J. D. Woodard
Vice President-Nuclear
Farley Project

Joseph M. Farley Nuclear Plant
Response to NRC Bulletin 88-10

Subsequent to this phone call a letter dated April 26, 1991 was received by Alabama Power Company requesting the following information for the Heinemann Model AM2-A3-A molded case circuit breaker in question:

HEINEMANN SERIES AM/S CIRCUIT BREAKERS

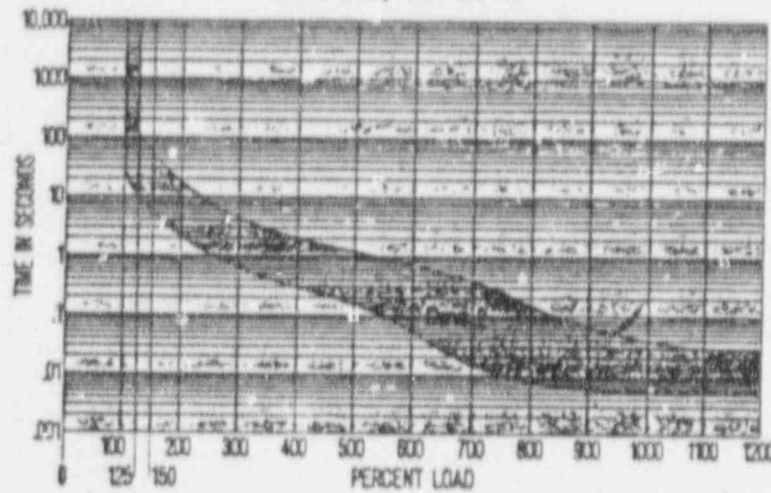
The manufacturer's time current curves indicate that at 100% of rated current the Heinemann breaker can trip in less time than the required one hour specified in NRC Bulletin 88-10 (as little as 20 seconds). When Wyle realized this they reduced the current to a value that allowed Wyle to test the breaker to verify that the breaker would "hold-in" for one hour and thus meet the intent of the testing criteria outlined in NRC Bulletin 88-10.

This breaker was purchased as a spare for the Inadequate Core Cooling Monitoring System (ICCMS) and, as shown by the Wyle test report, would function as intended by the manufacturer, if used as a replacement for the circuit breaker now in service. The 95.3% value (14.3 amps) is much higher than the ICCMS equipment load (less than 10 amps). If installed, the breaker would never see a prolonged load of 100% of its rated current during the normal operation of the ICCMS equipment. Therefore a one hour "hold-in" at 100% current is not required for this breaker to perform its intended function. If an increase in loading is ever needed, a design change and engineering evaluation would be required to determine the acceptability of the Heinemann breaker for the increased load. Additionally this spare circuit breaker would not be used for other safety-related applications at FNP without a design change which would include an engineering evaluation of the acceptability of the breaker, based on its electrical characteristics including its time-current curve.

It is Alabama Power Company's position that the Wyle test proved that the Heinemann breaker in question was not a counterfeit breaker since it performed in accordance with the manufacturer's published time current data.
